UNITED STATES PATENT AND TRADEMARK OFFICE

APPLICATION NO.	FILING DATE	FIRST NAMED INVENTOR	ATTORNEY DOCKET NO.	CONFIRMATION NO.
09/674,600	12/13/2000	Lorenz Camenzind	P/543-103	1539
2352	7590	09/08/2006	EXAMINER	
OSTROLENK FABER GERB & SOFFEN 1180 AVENUE OF THE AMERICAS NEW YORK, NY 100368403			VERBITSKY, GAIL KAPLAN	
			ART UNIT	PAPER NUMBER
			2859

Office Action Summary

DETAILED ACTION

Fig. 2

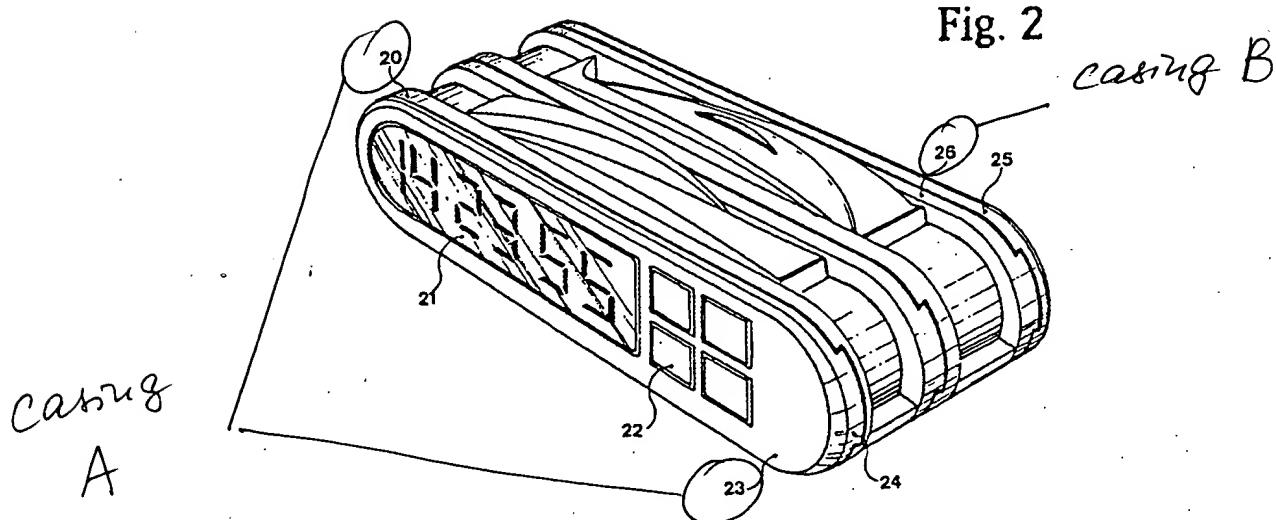
For claim 52: Schaub teaches in Fig. 2 a multifunctional tool comprising at least one pocket knife, at least one display and measuring device, display and a menu are arranged in one of at least two covers, the cover A (23 combined or integral with an inner module 20). Schaub states that a portion (internal module/ internal surface) 20 of the cover A is provided with expansion possibilities. This would imply, that the other modules could be mounted/ arranged to the inner surface of the portion 20, and that display and measuring devices would be arranged on the cover A and enclosing the knife along with another cover 26.

For claim 68: Schaub discloses in Fig. 2 a casing 23 which is integral with a cover 20 (on the casing 23) enclosing the knife along with another cover 26. The display and measuring device is arranged/ mounted onto the cover 20, and since the cover 20 is an

For claim 79: Schaub discloses in Fig. 2 a casing A (comprising a structure 23 and a structure 20). When the device is expanded, the display and measuring device is arranged/ mounted directly onto the internal surface of the casing A.

For claim 80: Schaub discloses in Fig. 2 a casing A (comprising a structure 23 integral with a cover 20) and casing B (structure 26). Thus, the cover 20 is an internal surface of the structure 23/ casing A. The knife is disposed within the casing A and B and, thus, within the cover plate 20. The display and measuring device, and a plurality of additional tools (modules) are located within the casing A and B. When the device is expanded, the display and measuring device is arranged/ mounted directly onto the internal surface of the casing A, which is the internal surface is a cover 20, as shown in Fig. 2. (The numerals A-B have been added by the Examiner, see attachment # 1 to the Office Action)
